**DRAFT CB XX-XX**

**ORDINANCE NO. XX**

**AMENDMENTS TO VOLUME 3, DEVELOPMENT CODE OF THE GRESHAM  
 COMMUNITY DEVELOPMENT PLAN, REGARDING PHASE ONE OF THE  
 DEVELOPMENT CODE AND PROCESS UPDATES (DCPU) PROJECT**

### Map 4.1140: Downtown Street Types

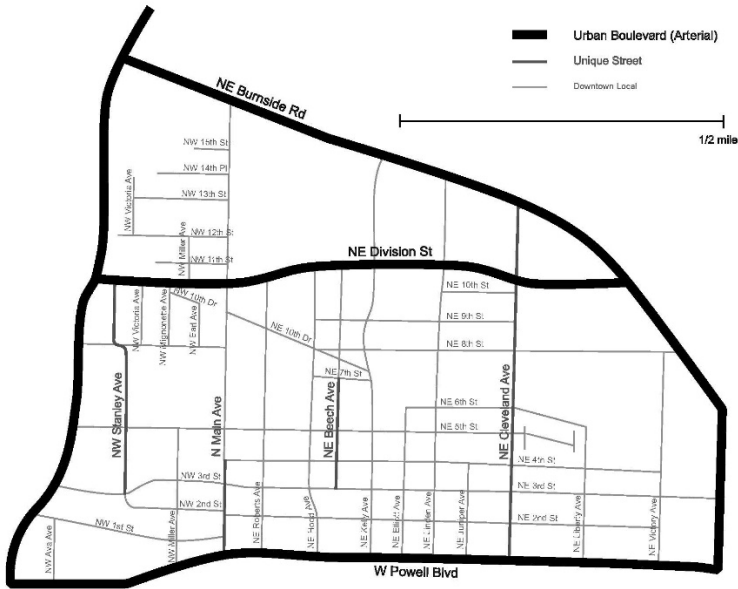
*Update map to clarify south end of Stanley unique street type is at 3<sup>rd</sup> St.*

**Map 4.1243: Civic Neighborhood Streets and Future Streets**

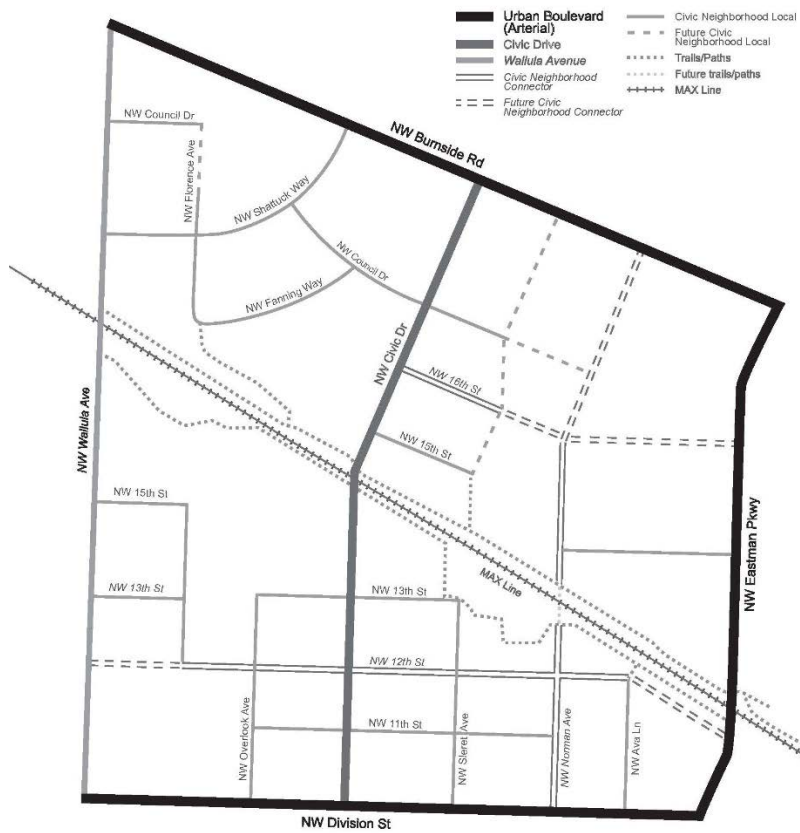
*Update map format for legibility and clarify trails/paths.*

**Diagram E.1: Civic Neighborhood Local Street Type Cross Section**

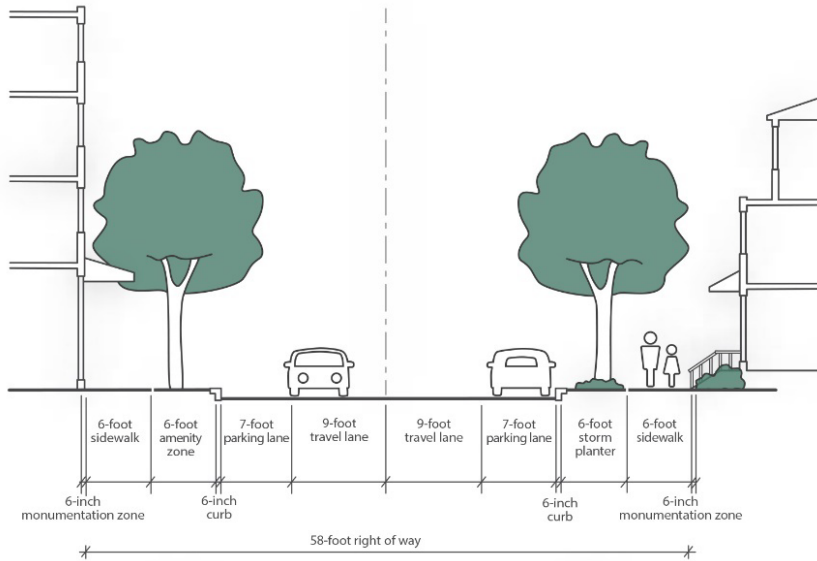
*Update cross-section travel lanes from 11 ft. to 9 ft. and sidewalk amenity zones from 11 ft. to 13 ft. for greater pedestrian orientation.*

**Diagram E.2: Civic Neighborhood Local Street Type Plan View Diagram**

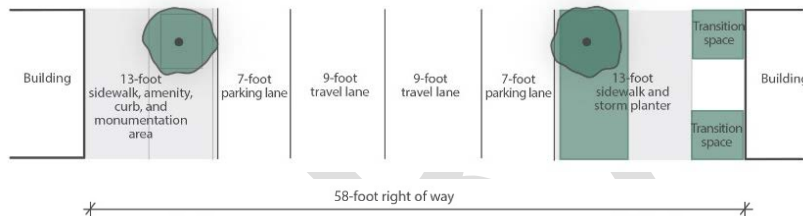
*Update plan view travel lanes from 11 ft. to 9 ft. and sidewalk amenity zones from 11 ft. to 13 ft. for greater pedestrian orientation.*
